November 6, 2015

Re: **Status Report and Change Order No 1 Request**  
Dry Cleaners, Etc.  
102 East Cook Street  
New London, Wisconsin  
BRRTS # 02-69-552218  
Terracon Project No. 58107028

On behalf of Dry Cleaners, Etc., Terracon Consultants, Inc. (Terracon), prepared this status report and change order request to document NR 716 site investigation (SI) work performed to date, and present a work plan to delineate the magnitude and extent of the chlorinated volatile organic compound (CVOC) affected soil, groundwater, and air associated with the former Dry Cleaners Etc. property located at 102 East Cook Street, New London, Wisconsin (Figure 1). The SI work was performed in accordance with our proposal/work plan dated November 19, 2008, which was approved on July 2, 2009.

| BORING AND MONITORING WELL LOCATIONS                               |  |

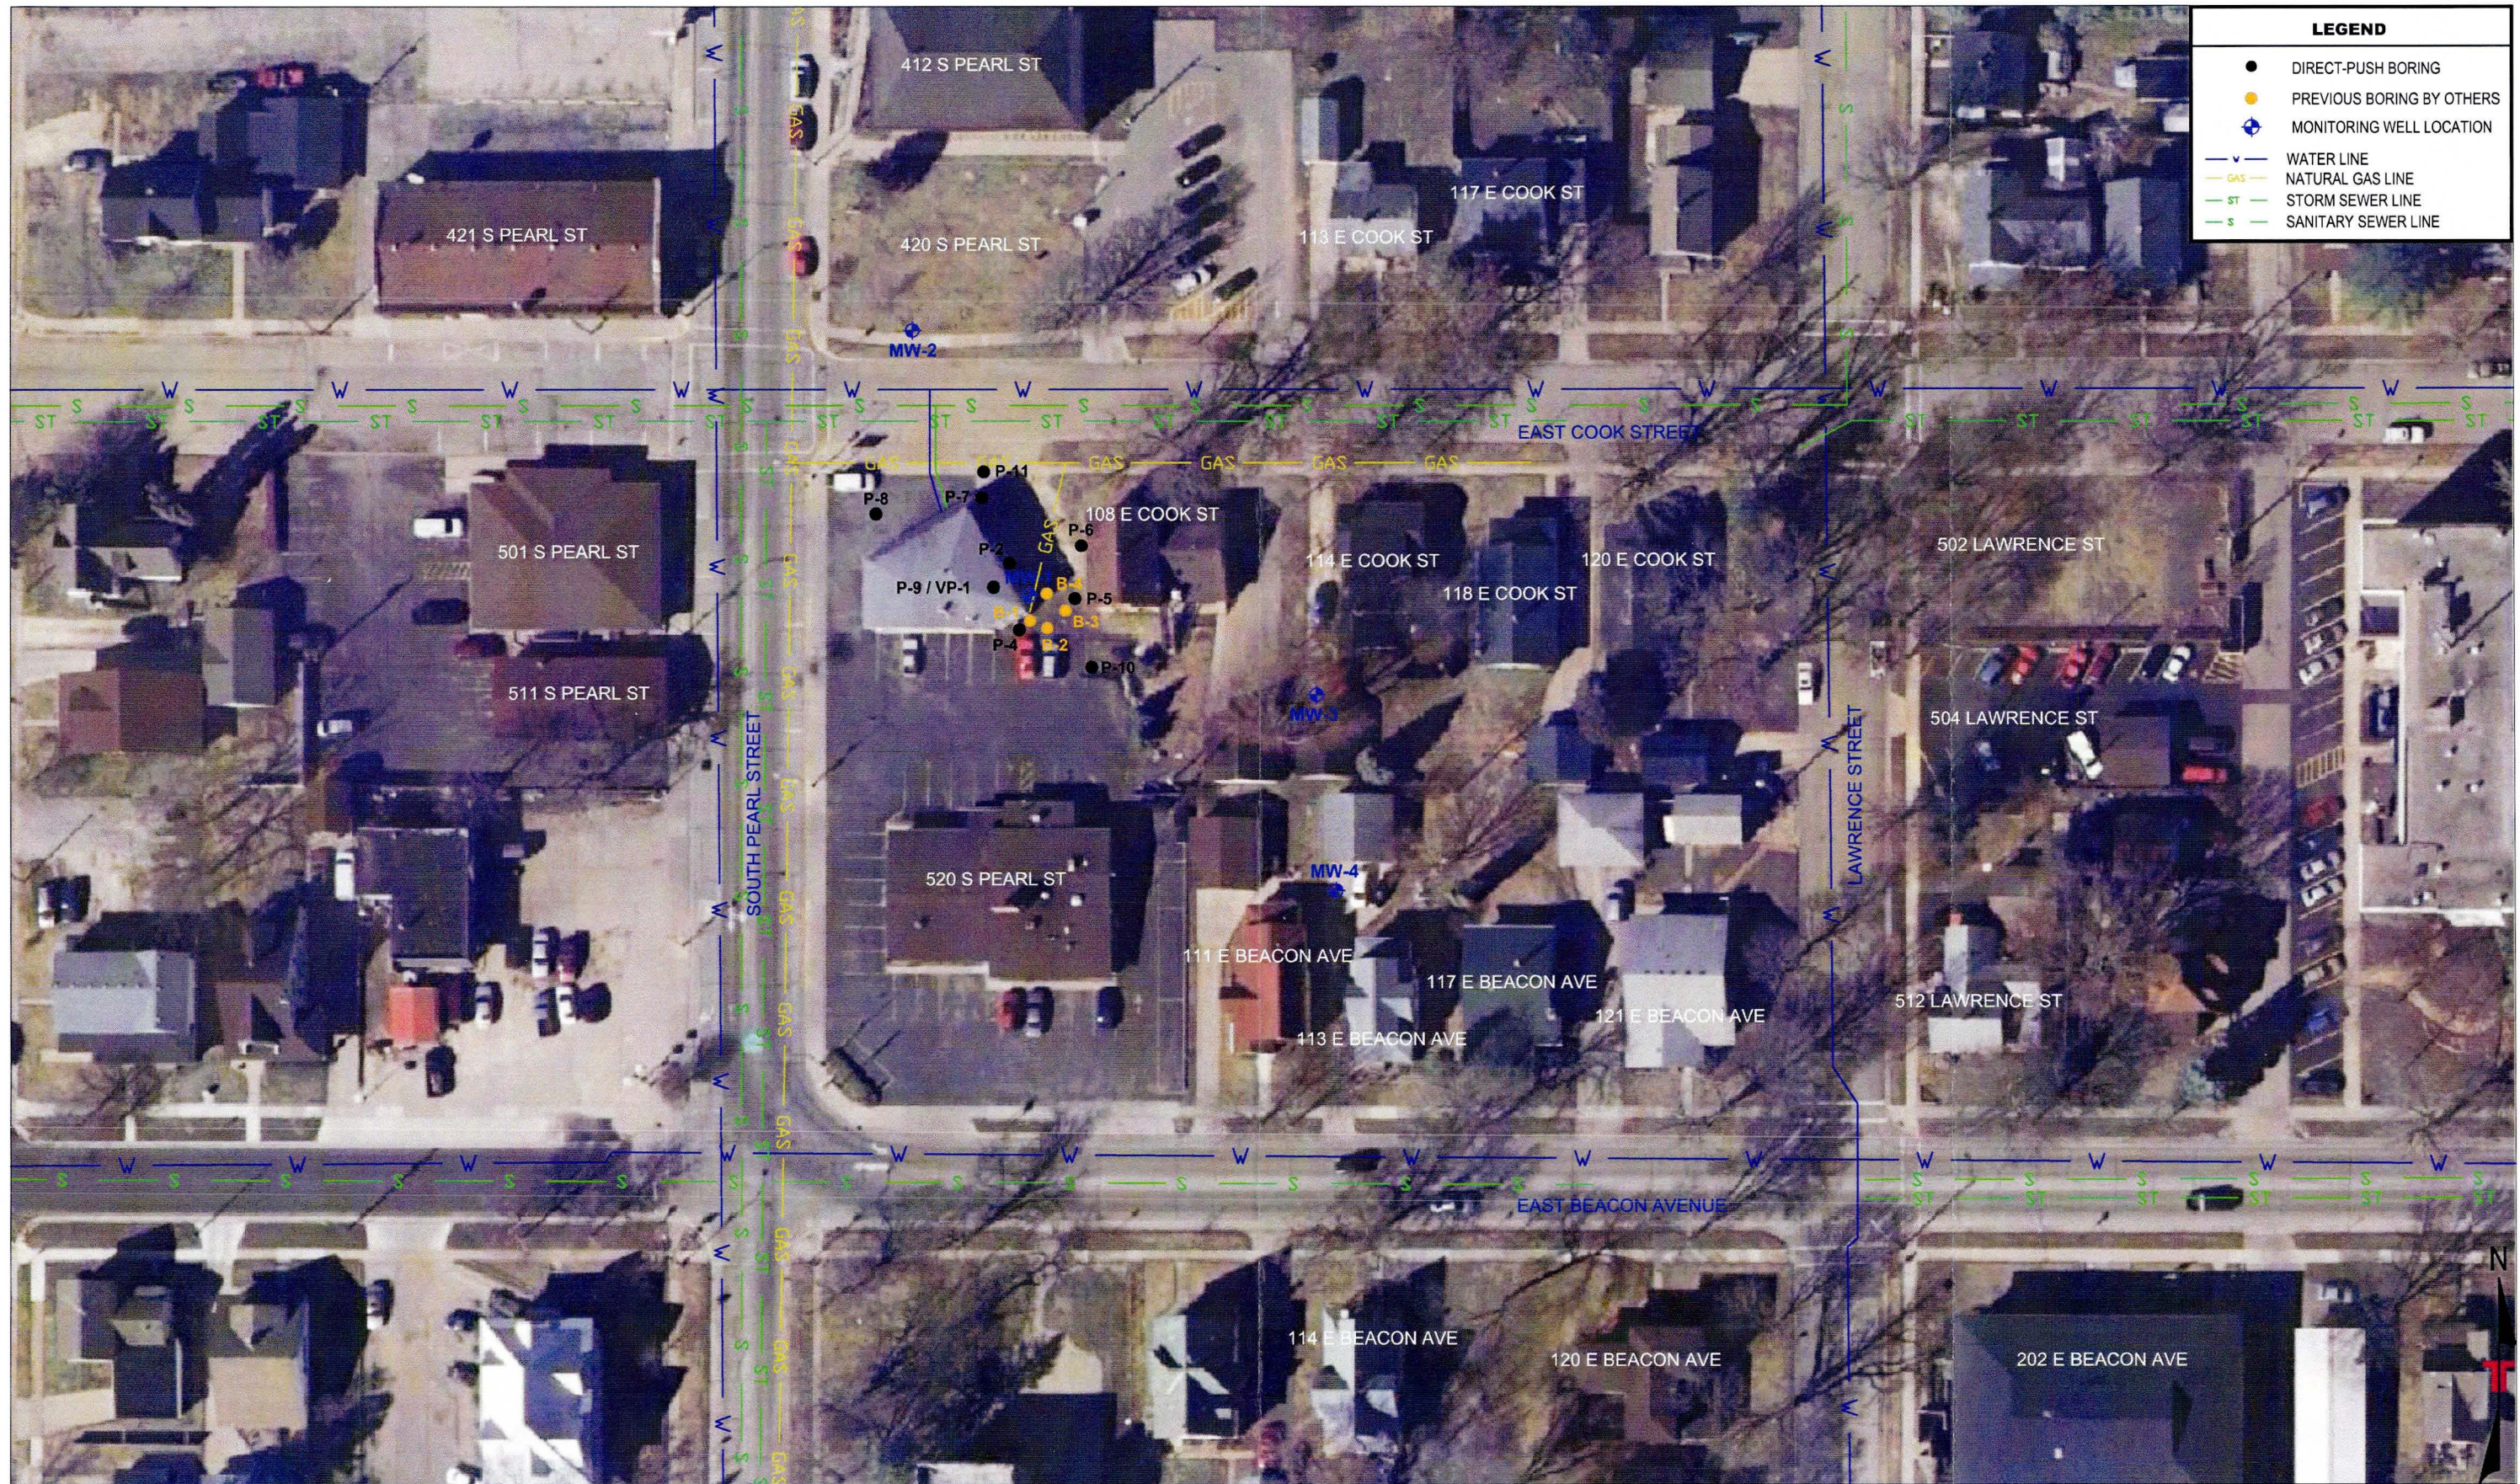
*Four borings not on Figure 2 converted to wells Found them different symbol*

| PROPOSED SAMPLING LOCATIONS  |  | FIG. No. |

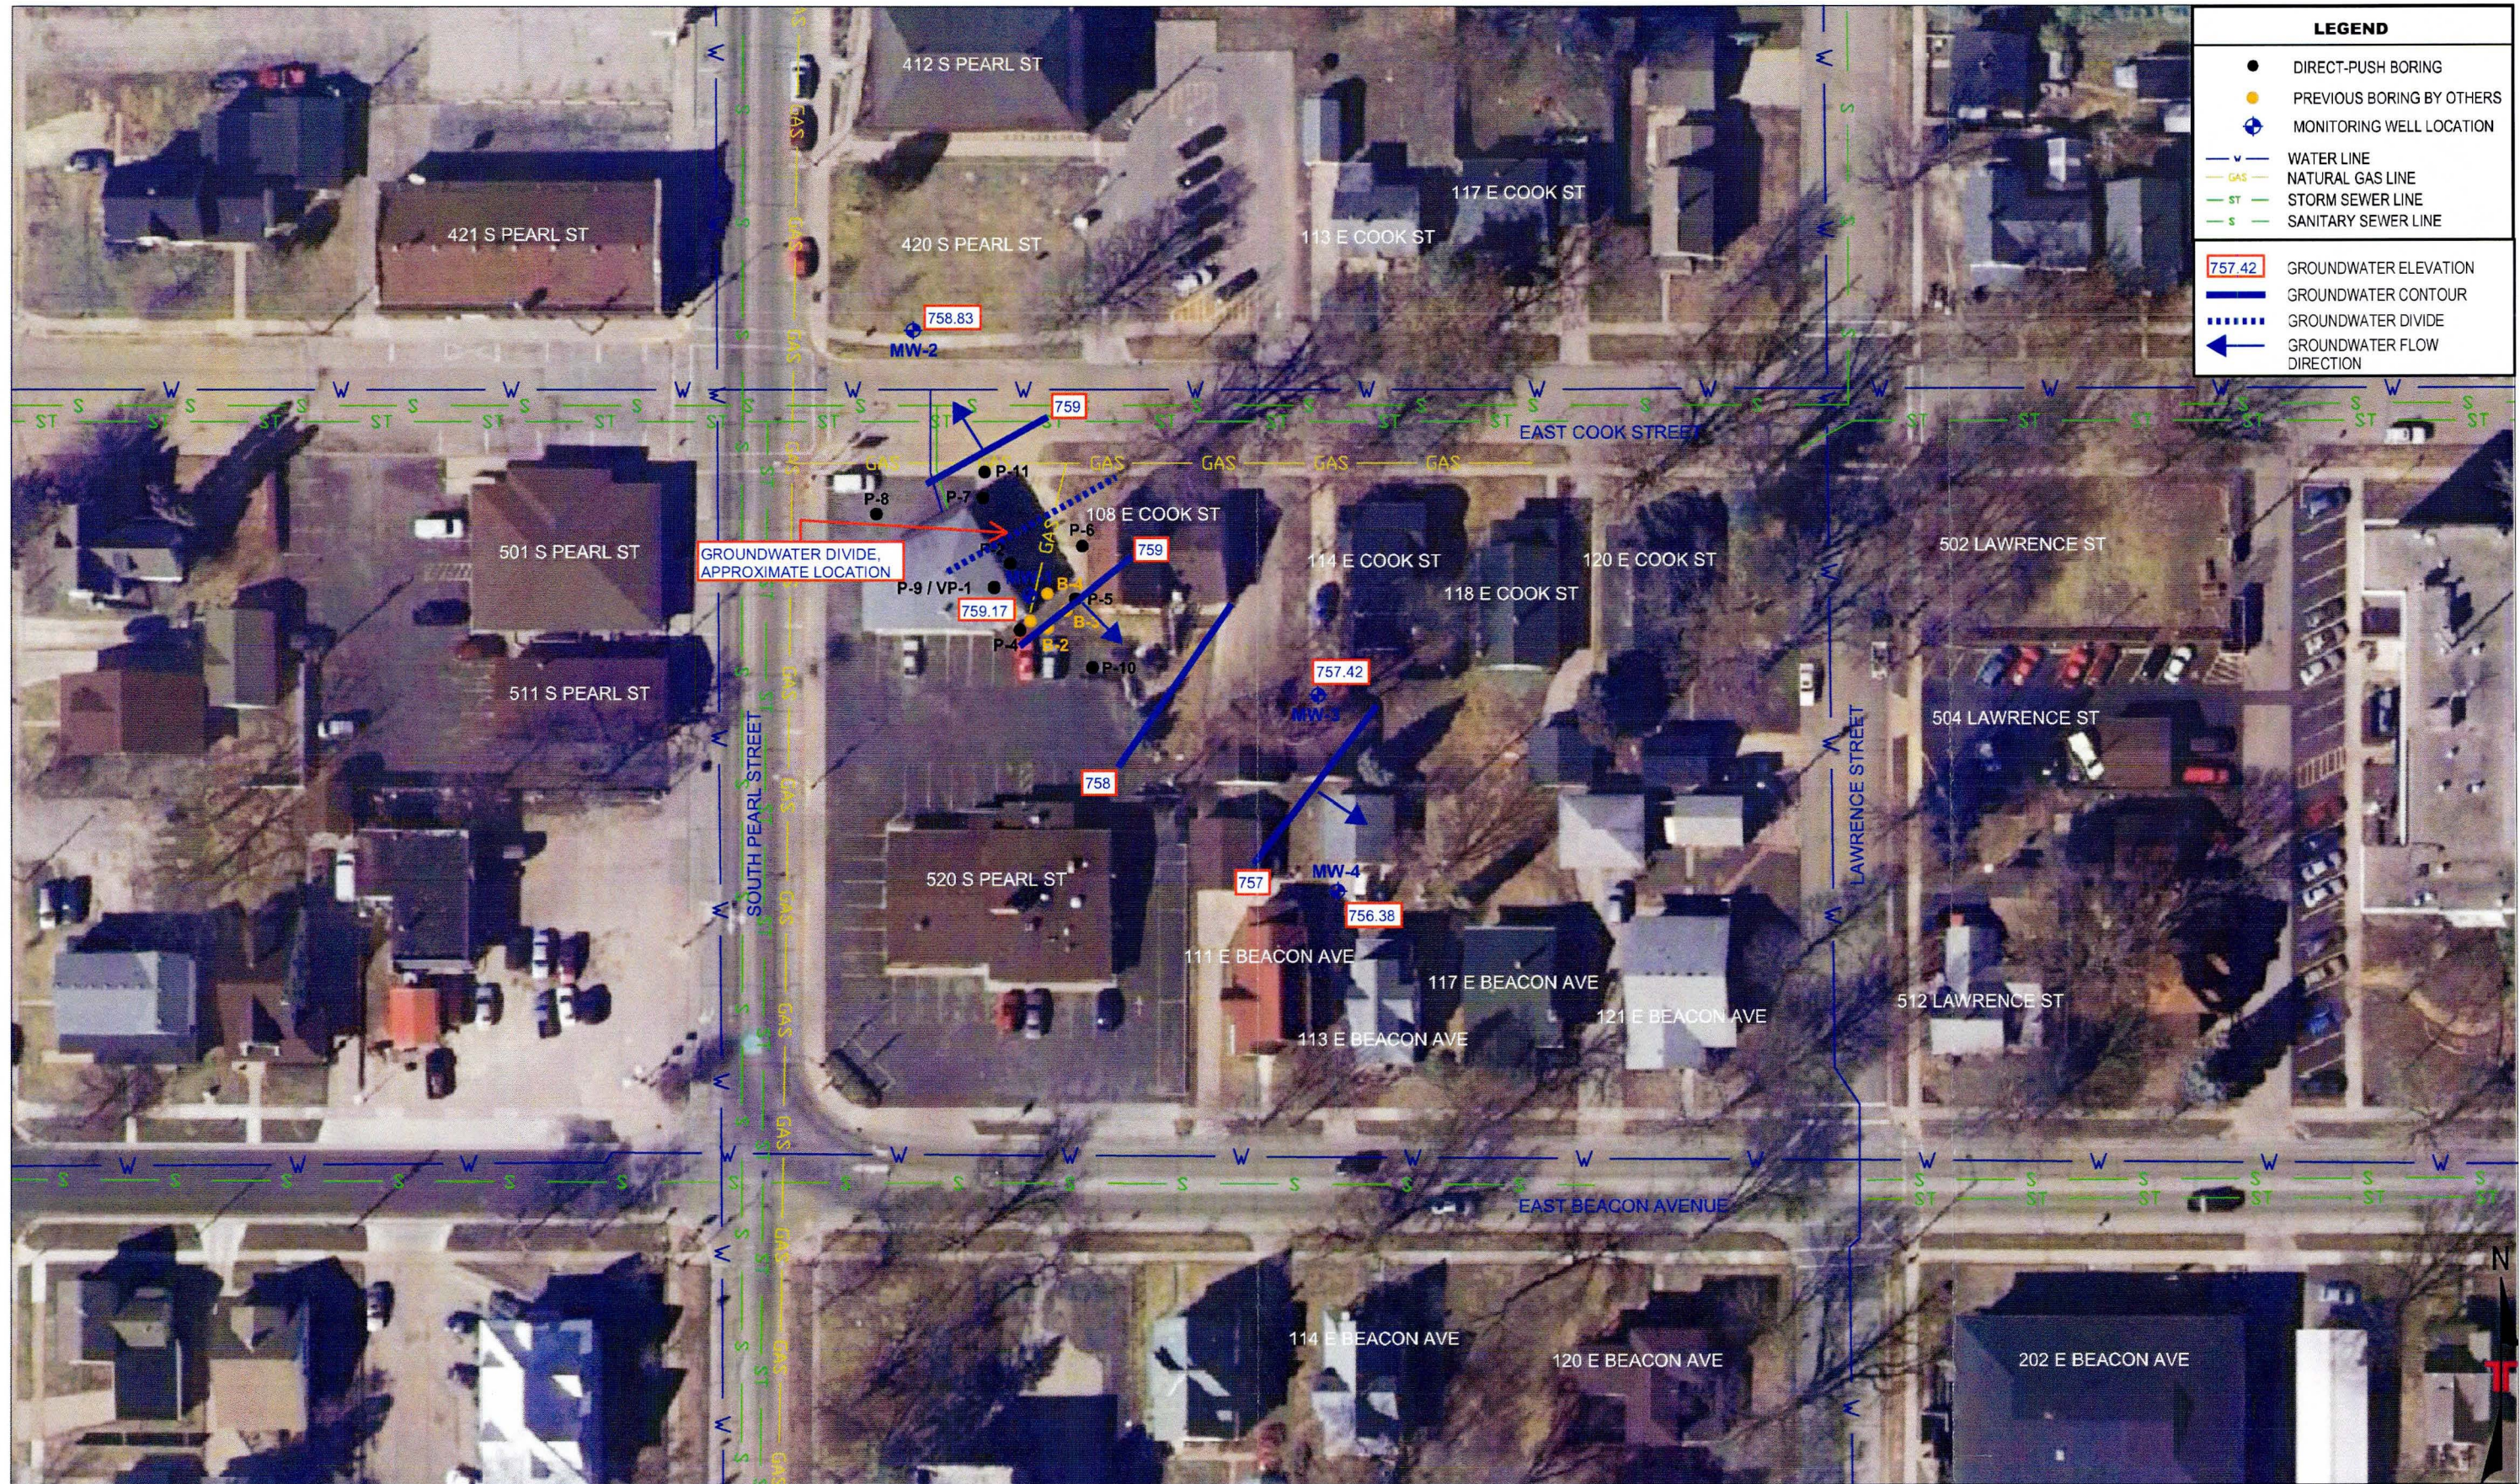
*3 around MW-2? Fig 4*

111 E-Beacon Ave

Who and where?  
\*  
111 E Beacon Ave.
